UNITED STATES
NUCLEAR REGULATORY COMMISSION
WASHINGTON, D. C. 20555

SUBJECT: SUMMARY OF MEETING WITH THE COMBUSTION ENGINEERING OWNERS
GROUP (CEOG) REGARDING THE DEFAS DESIGN FEATURES TO BE
INSTALLED PER 10 CFR 50.62 (THE ATWS RULE)

A summary of the staff's comments on the information presented at the two meetings cited above is presented below. Enclosure 2 is a copy of the slides presented by the CEOG on July 12, 1989.

**PRESENTATION ON THE RESPONSE
TO
THE NRC REQUEST FOR ADDITIONAL INFORMATION
ON
CE NPSD-384
DESIGN FOR A DIVERSE EMERGENCY FEEDWATER
ACTUATION SYSTEM CONSISTENT WITH
10CFR50.62 GUIDELINES**

3410 MWt PLANT CLASS
LOFW ATWS
PEAK PRESSURE VERSUS MODERATOR TEMPERATURE COEFFICIENT

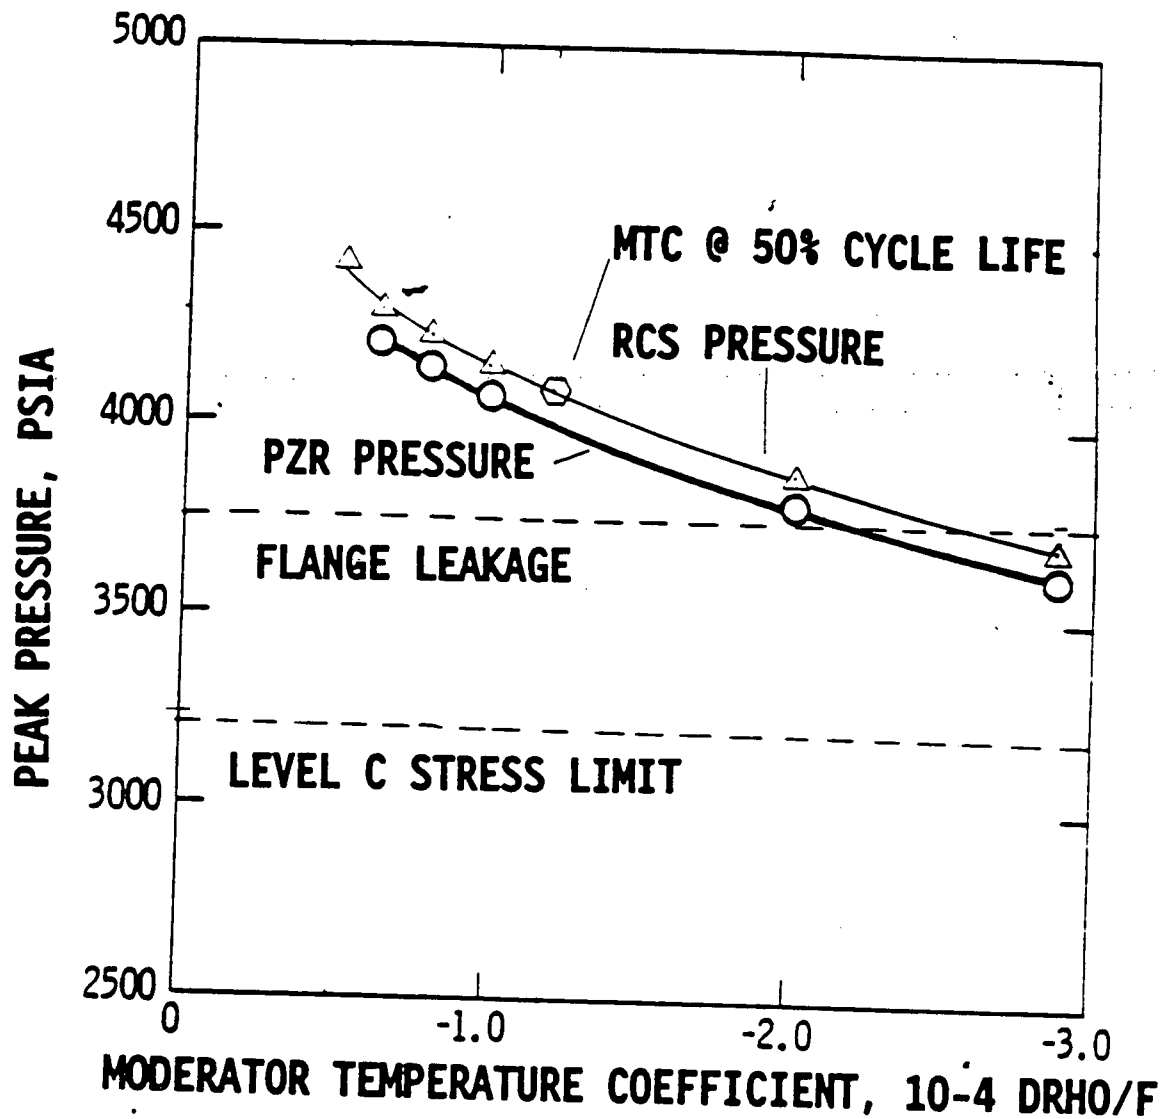
PROVIDE A DISCUSSION OF SGLL AS AN ALTERNATIVE TO THE DSS INTERLOCK

WILL EARLIER AUX. FEED ACTUATION MITIGATE AN ATWS EVENT FOR LATER TIMES IN THE CYCLE

FOR LIMITING ATWS SCENARIO, AUX. FEED TIMING HAS LITTLE IMPACT ON PEAK PRESSURE

FOR THE 3410 MW_T CLASS THERE IS NO TIME IN THE CYCLE WHICH YIELDS ATWS PEAK PRESSURES BELOW LEVEL C STRESS LIMITS (CENPD-263)

FOR THE 3800 MW_T CLASS THERE MAY BE A SMALL IMPACT ON PEAK PRESSURE FOR LATER TIMES IN CORE CYCLE, I.E., BELOW LEVEL C STRESS LIMITS (CENPD-263)
